Access Compliance Report

Public Rights-of-Way

(Curb Ramps)

Intersection ID: 52521	Main Street: LORNA_ST	Cross Street: MCCLINTOCK_RD	Location: E
ADA ID: C75E43EA509F	Ramp Type: Perp	Initial Pass/Fail: Fail	Overall Compliance: No
Severity Score: 8.75			
Codes/Mitigation Info/Possible Solution		Field Measurements/Component Compliance

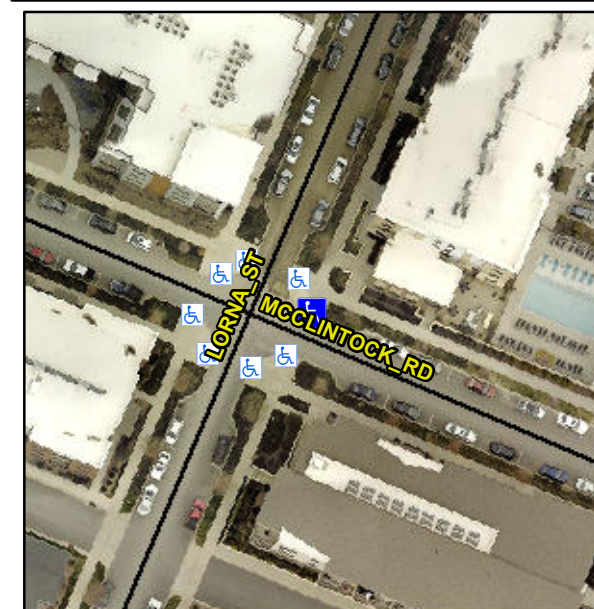
R304.5.1

Compliance	Description	Data	Compliance	Description	Data
N/A	Ramp Length (in)	77.5	Yes	Ramp Slope (%)	6.4
No	Ramp Width (in)	47.0	Yes	Ramp XSlope (%)	1.5
N/A	Flare Type LT	N/A	N/A	Flare Type RT	N/A
N/A	Flare Slope LT (%)	N/A	N/A	Flare Slope RT (%)	N/A
N/A	Flare Traversable LT?	N/A	N/A	Flare Traversable RT?	N/A
N/A	Landing Length (in)	N/A	N/A	DWS Provided?	N/A
N/A	Landing Width (in)	N/A	N/A	DWS Contrast?	N/A
N/A	Landing Slope (%)	N/A	N/A	DWS Length (in)	N/A
N/A	Landing X Slope (%)	N/A	N/A	DWS Full Width?	N/A
N/A	Landing Curb? (Y/N)	N/A	N/A	DWS Offset (in)	N/A
N/A	Shared Landing?	N/A			
N/A	Gutter Ponding?	N/A	N/A	Gutter Slope (%)	N/A
N/A	Gutter Lip Ht (in)	N/A	N/A	Gutter X Slope (%)	N/A
N/A	Painted X Walk1?	No	N/A	Painted X Walk2?	N/A
	X Walk 1 Direction	To SW		X Walk 2 Direction	N/A
N/A	X Walk 1 Width (in)	N/A	N/A	X Walk 2 Width (in)	N/A
	X Walk 1 Slope (%)	6.7		X Walk 2 Slope (%)	N/A
	X Walk 1 X Slope (%)	2.1		X Walk 2 X Slope (%)	N/A

Remove & Replace Entire Ramp.
